### APPEAL SUMMARY

<b>Appeal ID:</b> 18961	<b>Project Address:</b> 619 NW 6th Ave
<b>Hearing Date:</b> 2/6/19	<b>Appellant Name:</b> Erkki (Erik) Ojala
<b>Case No.:</b> B-014	<b>Appellant Phone:</b> 503-863-2408
<b>Appeal Type:</b> Building	<b>Plans Examiner/Inspector:</b> Maureen McCafferty, Geoff Pena, Thomas Ng
<b>Project Type:</b> commercial	<b>Stories:</b> 9 <b>Occupancy:</b> <b>Construction Type:</b> 1-B
<b>Building/Business Name:</b> Multnomah County Health Headquarters	<b>Fire Sprinklers:</b> Yes - Throughout building per NFPA 13
<b>Appeal Involves:</b> Erection of a new structure	<b>LUR or Permit Application No.:</b> 16-227322-CO
<b>Plan Submitted Option:</b> pdf [File 1] [File 2] [File 3]	<b>Proposed use:</b> Office and medical office

MULTNOMAH  
COUNTY HEALTH  
DEPARTMENT  
HEADQUARTERS

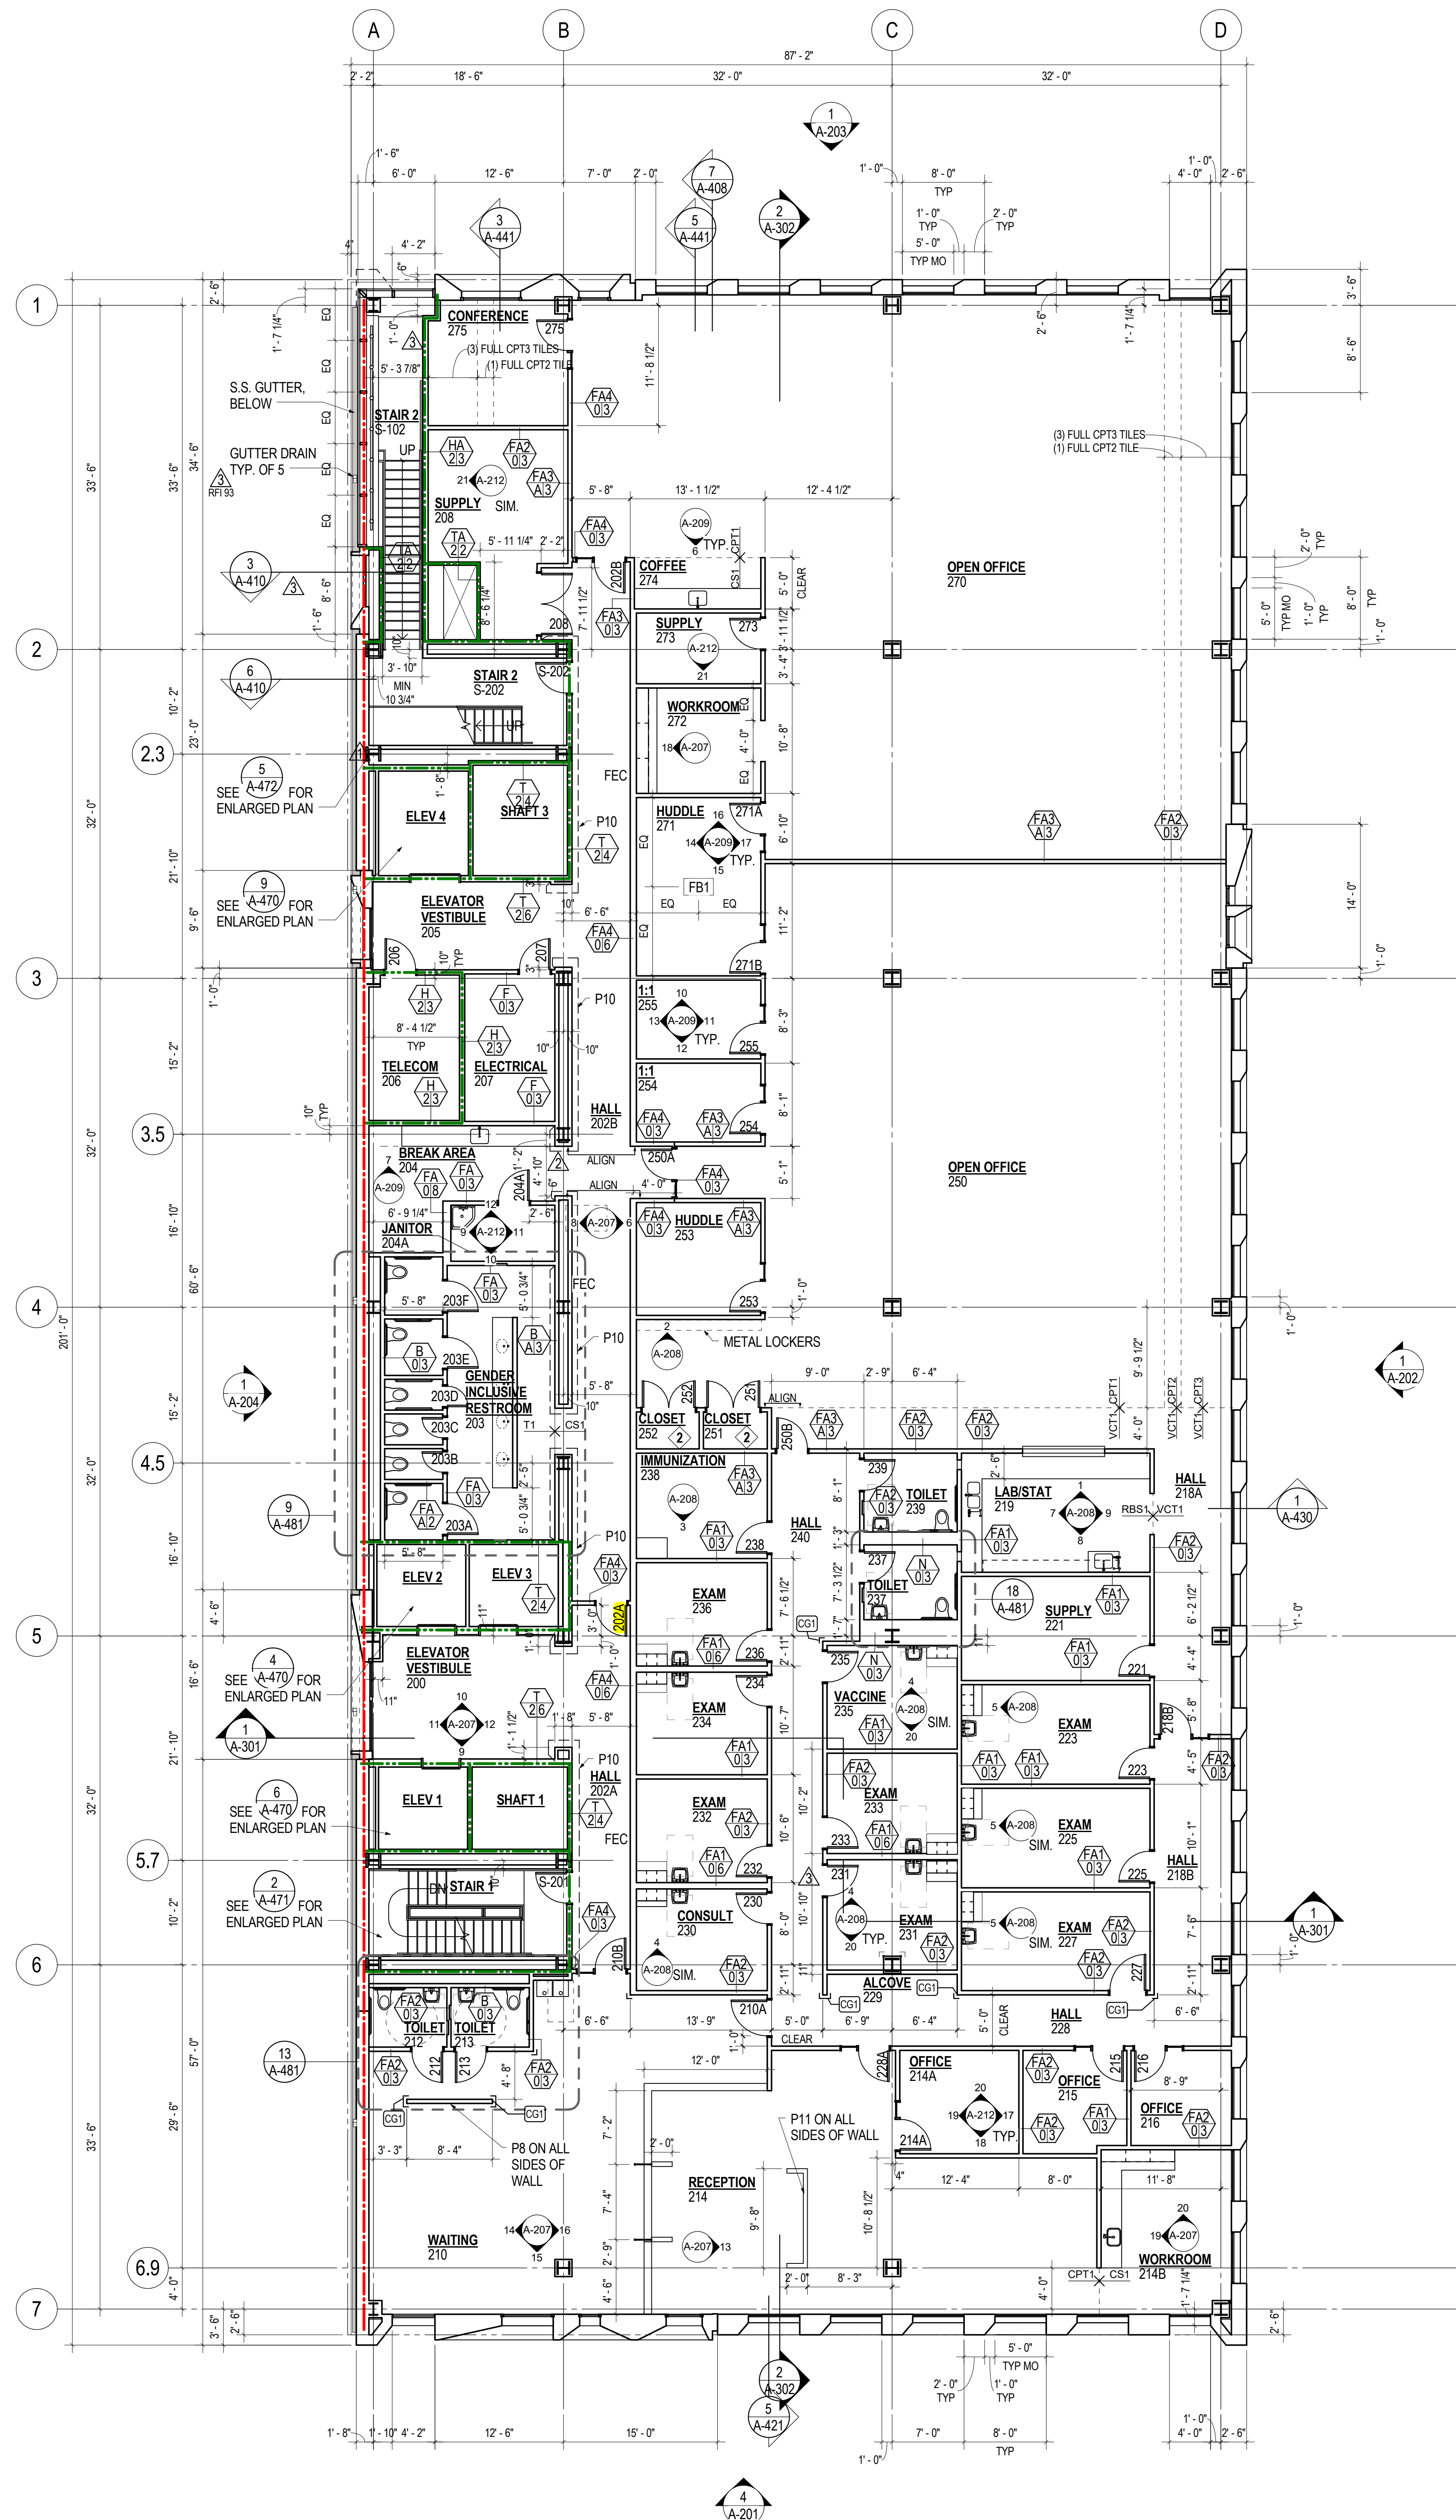
<b>Code Section</b>	OSSC 1008.1.9.8
<b>Requires</b>	<p>Access-controlled egress doors, criteria #3: The doors shall be arranged to unlock from a manual unlocking device located 40 inches to 48 inches (1016 mm to 1219 mm) vertically above the floor and within 5 feet (1524 mm) of the secured doors. Ready access shall be provided to the manual unlocking device and the device shall be clearly identified by a sign that reads "PUSH TO EXIT." When operated, the manual unlocking device shall result in direct interruption of power to unlock – independent of the access control system electronics - and the doors shall remain unlocked for a minimum of 30 seconds.</p>
<b>Proposed Design</b>	<p>The proposed Multnomah County Health Department Headquarters (MCHD) project is a high-rise Type 1B building with an automatic sprinkler system in accordance with Section 903.3.1.1. The building is 9 occupied stories, with 8 levels of primarily B-occupancy office and outpatient clinic space above a ground floor level that includes primarily B and S-1 occupancies and a non-occupied 10th level mechanical penthouse.</p> <p>The cross-corridor doors 202A, 302A, 402A, 502A, 602A, 702A, 802A and 902A currently allow free access for exiting from the north to the south but are card reader access from south to north. We propose that the door hardware be revised to release the lock on fire alarm allowing egress from south to north as well.</p> <p>Please see the attached exhibit drawing A for additional information.</p>

<b>Reason for alternative</b>	Multnomah County Health Department Headquarters (MCHD) will house both administrative and outpatient clinical functions. The clinic client population is quite varied and can present dangerous

or violent situations at times. Many are "mental health" patients. The County has consistently had violent encounters with their client base. It is essential that staff areas be secure for these situations for the protection of staff and for staff to take other clients to refuge. The County has protocol in place to deal with these situations. These cross-corridor doors cannot allow unsecure access to staff areas. The waiting room occupant load that exits from the south is less than 50 so one exit is required. The adjacent staff areas have two or more exit routes out to Stairs 1 and 2. We propose to comply with the other criteria in this code section so that fire alarm, fire sprinklers or loss of power will release these door locks, but no manual unlocking will be provided. The current condition for these doors and hardware function were approved in Permit Plan Review. This will be an enhancement to the permit condition. This will provide the safety necessary in fire and power loss events and that the County Protocol will provide safety in other emergency events. This will provide equivalent life safety and fire protection.

**1. Release of access controlled egress doors by fire alarm signal or loss of power: Granted provided a communication device with instructional signage is provided at the specified doors to allow contact with a constantly attended location.**

For Item 1. The Administrative Appeal Board finds with the conditions noted, that the information submitted by the appellant demonstrates that the approved modifications or alternate methods are consistent with the intent of the code; do not lessen health, safety, accessibility, life, fire safety or structural requirements; and that special conditions unique to this project make strict application of those code sections impractical.

Figure 5: Elevator 4, Shaft Report – Summer Design Conditions

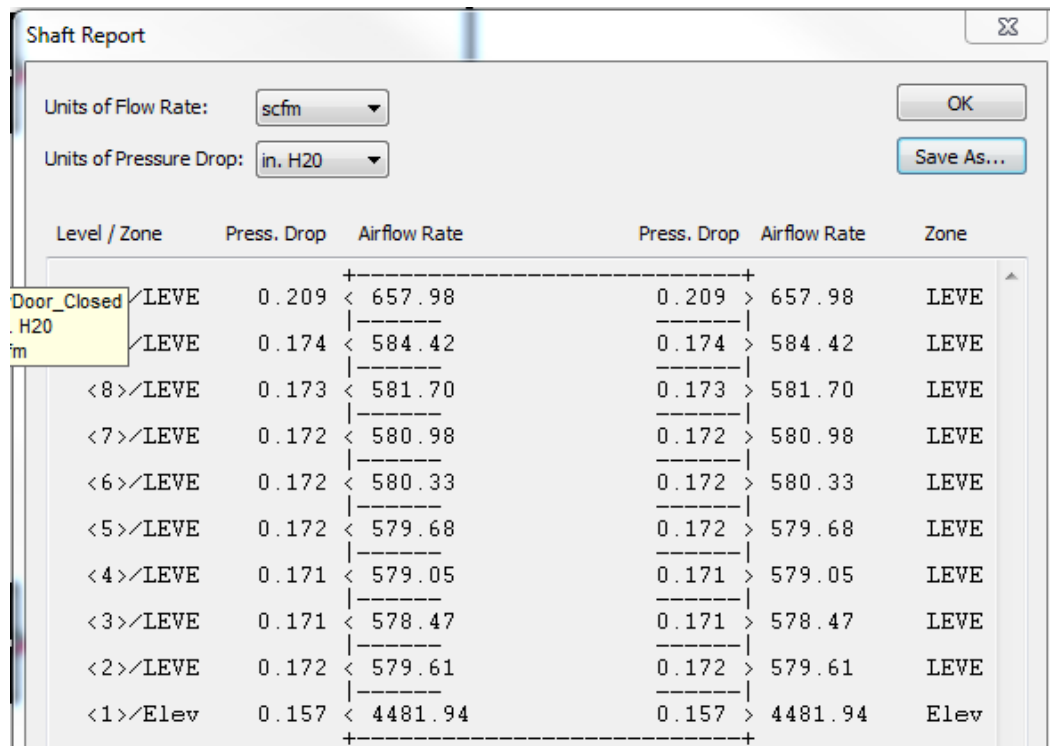
Figures 1-5 below show results for the summer design conditions (91.2°F, 25mph south wind). Each figure is a "shaft report" generated by the CONTAM software for the respective shaft. The left columns indicate the pressurization and air leakage through the interior walls, while the right columns indicate the pressurization and air flow through the doors (or door cracks, when the doors are closed). For the stairwells, the pressure drops all fall in the required 0.10-0.35 in. H<sub>2</sub>O range required by code, and the elevator hoistway pressure drops are in the required 0.10-0.25 in. H<sub>2</sub>O range. All pressures are recorded at the median height of the respected door/wall.
